MARTY FELDMAN CHEVROLET/KIA DEALERSHIP SP 11-04

Public hearing on the request of Marty Feldman Chevrolet/Kia Dealership for Preliminary Site Plan, Phasing Plan, Stormwater Management Plan and Special Land Use Permit. The subject property is located on the south side of Grand River Avenue, west of Meadowbrook Road, in Section 23 of the City. The property totals 9.8 acres. The zoning of the parcel is currently split between B-3, General Business and P-1, Vehicular Parking

PLAN REVIEW CENTER REPORT

Planning Review of Preliminary and Final Site Plan

SITE PLAN

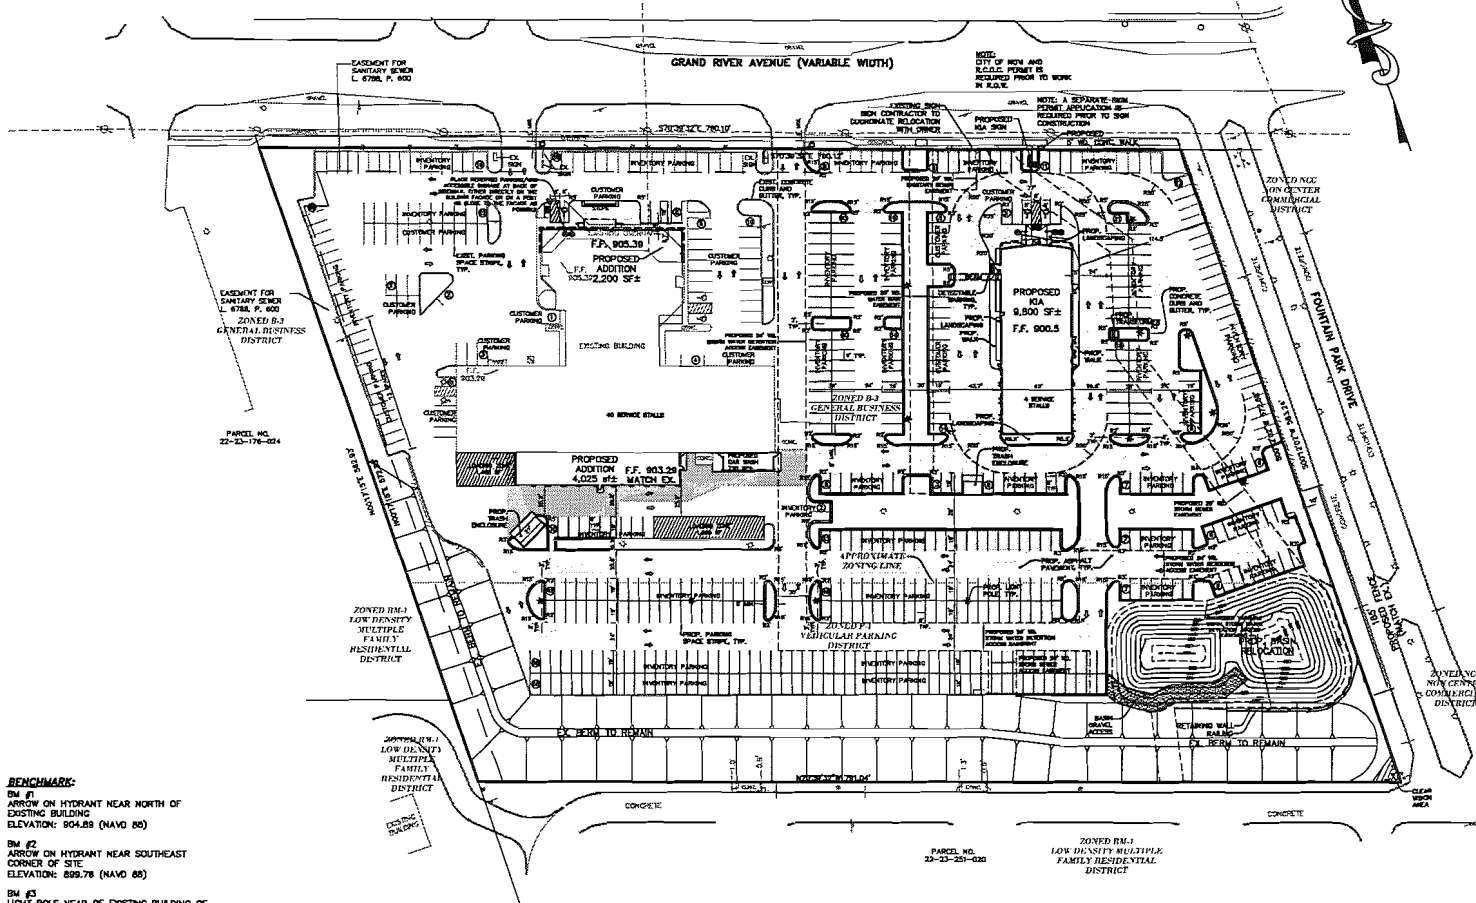
1. The first landscape island south of the Chevrolet building will be altered so as to eliminate parking along the island's south side. **The new curb return radius at the southeast corner of this island should be 15 ft rather than the 8 ft proposed.**

2. As can be seen in the attached aerial photo, the crosshatching in the larger (1,895-s.f.) loading zone already exists and slants from northwest to southeast, rather at the much different angle portrayed on the proposed site plan. **To accurately document the striping treatment and eliminate any confusion when it comes to inspecting the site upon completion of improvements, the crosshatching to be retained and used in the new layout should be reoriented to reflect reality, and labeled as "existing."** The new zone at the building's southwest corner should be striped in the same manner, and both zones should be equipped with a **NO PARKING - LOADING ZONE (R7-6)** sign.

- 3. The symbols used to indicate STOP signs at the site access drives should be revised to more clearly show a capital C within a circle (as in the signing table).**

1. The new curb return radius at the southeast corner of the first landscape island south of the Chevrolet building will be revised from 8 ft to be 15 ft. This will be provided on the Final Site Plan stamping sets.
2. The loading zone crosshatching to be retained and used in the new layout will be reoriented to reflect reality and labeled as existing. The new zone at the southwest corner will be striped in the same manner and both zones equipped with no parking – loading zone signage. This will be provided on the Final Site Plan stamping sets.
3. The signing denotation for the stop signs will be enlarged to clearly show the letter C on the Final Site Plan stamping sets.
